GENERAL CONSTRUCTION NOTES

# C1.0

KITTRICK PLACE STREET  
IMPROVEMENT PLAN

DAELYN DRIVE &amp; SOPHIA LANE DETAIL GRADING

HENZLEE PLACE (STREET C) – PUBLIC 50' R.O.W.  
25 MPH DESIGN SPEED (LOCAL)

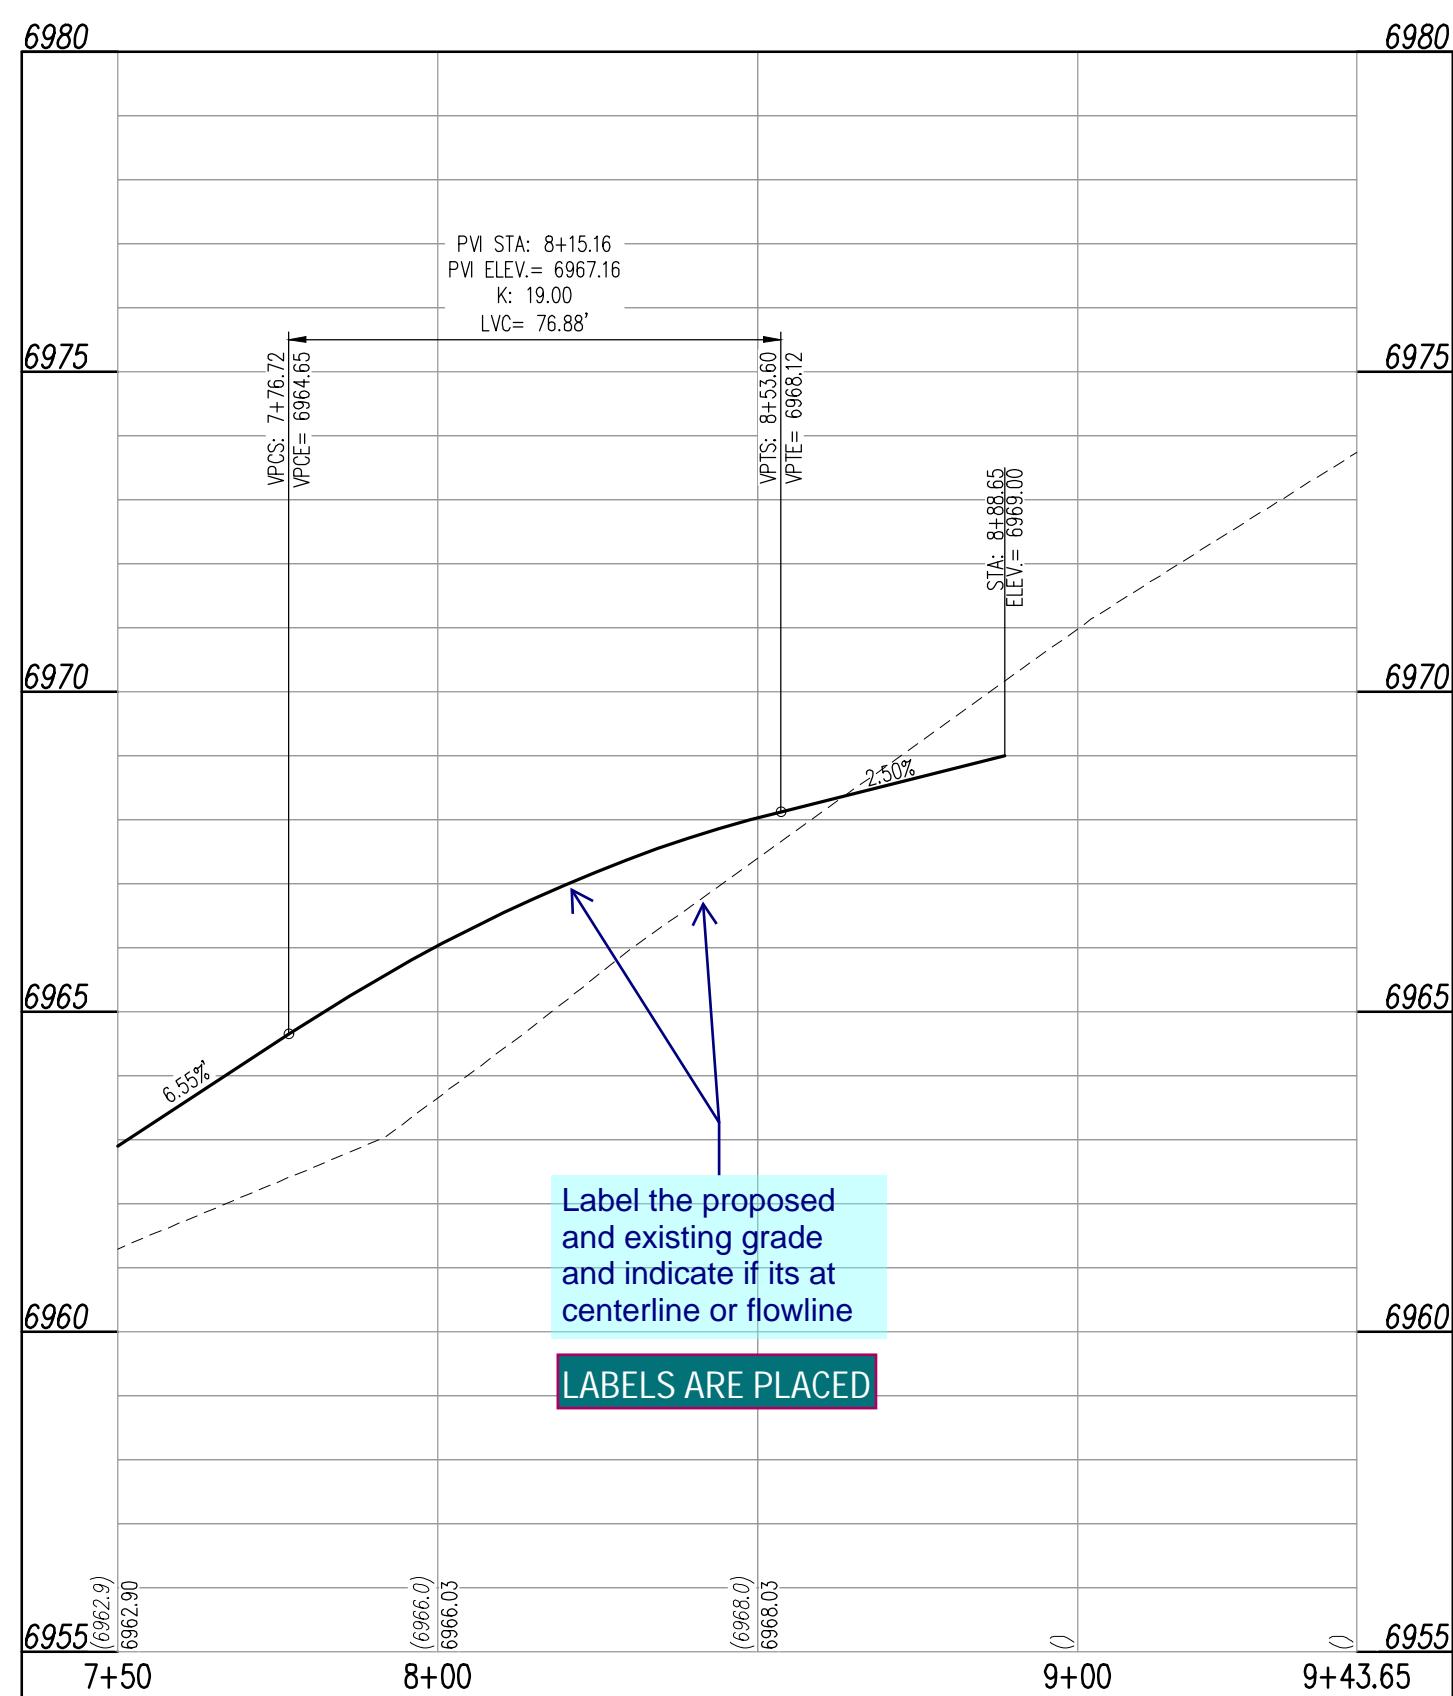
Please indicate the grade at the cul-de-sac bulb. Per ECM figure 2-31, the max slope shall be 3%

SLOPE LABELS ARE PRESENT  
AND SLOPE IS ADJUSTED TO  
MAX 3% STANDARD

HENZLEE PLACE (STREET C)  
STA: 7+50 - 9+43.65 SCALE: H: 1"=30' V: 1"=3'

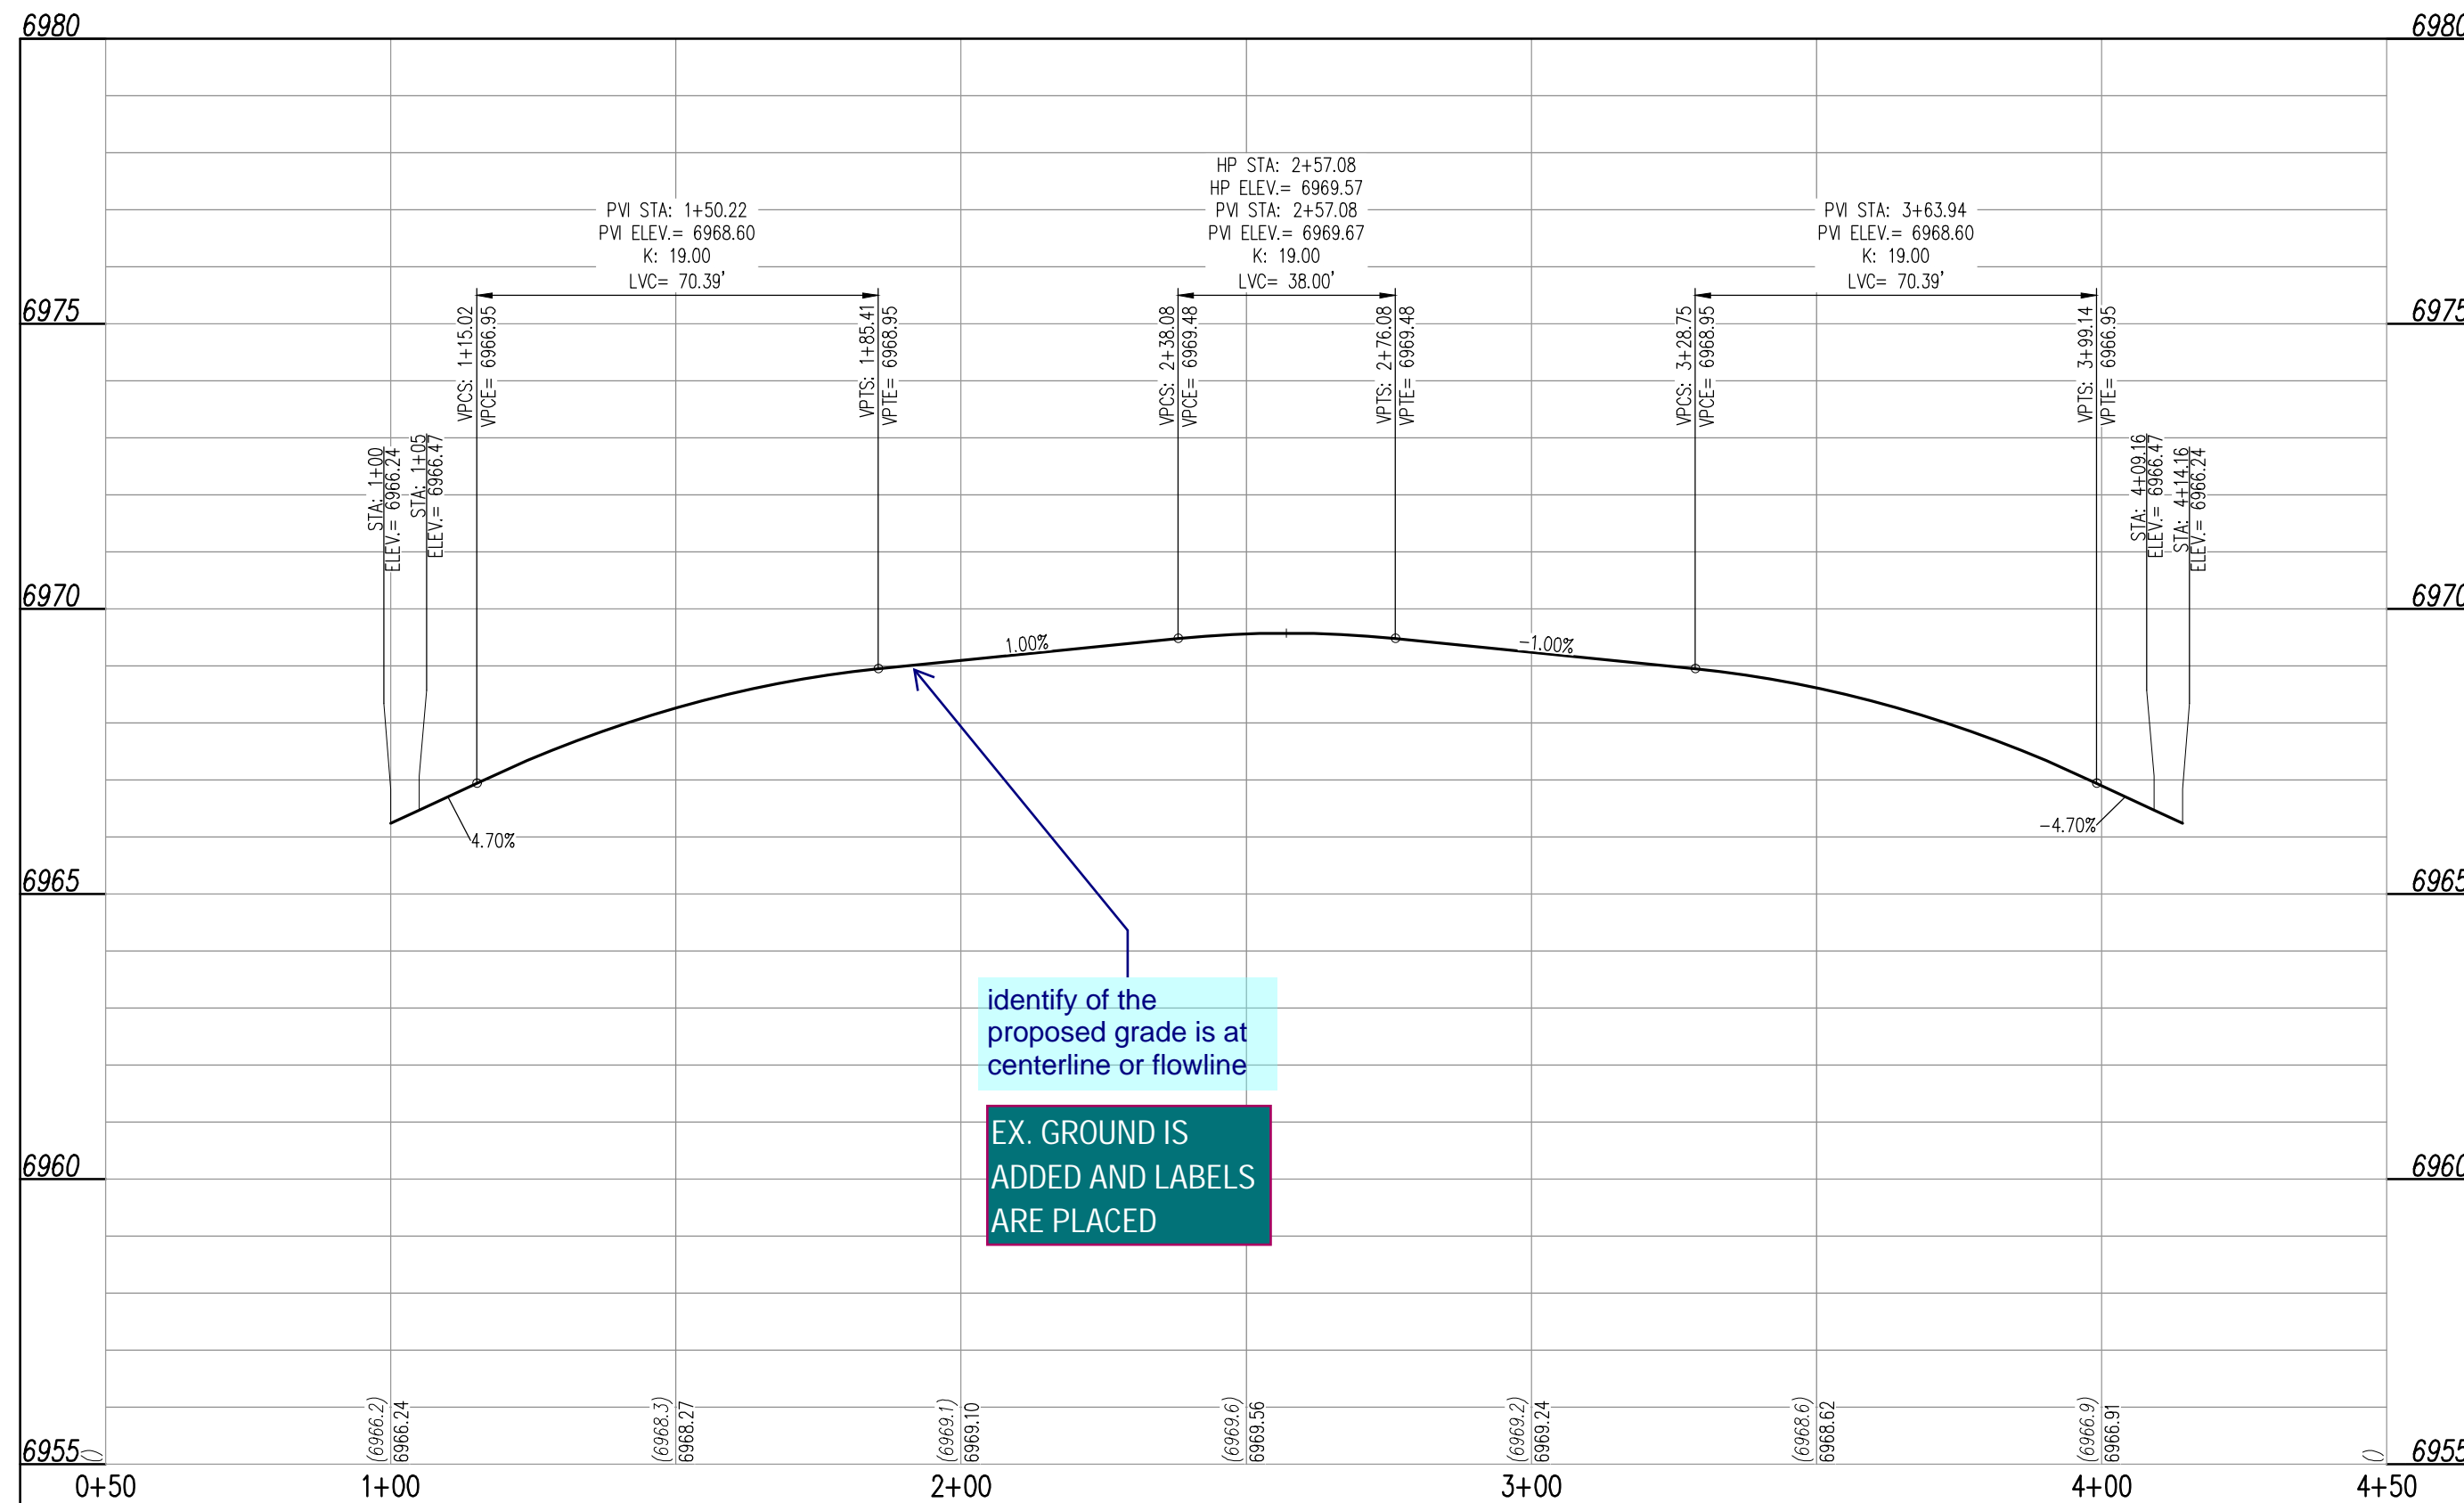
Label the proposed and existing grade and indicate if its at centerline or flowline

EX. GROUND IS ADDED AND LABELS ARE PLACED
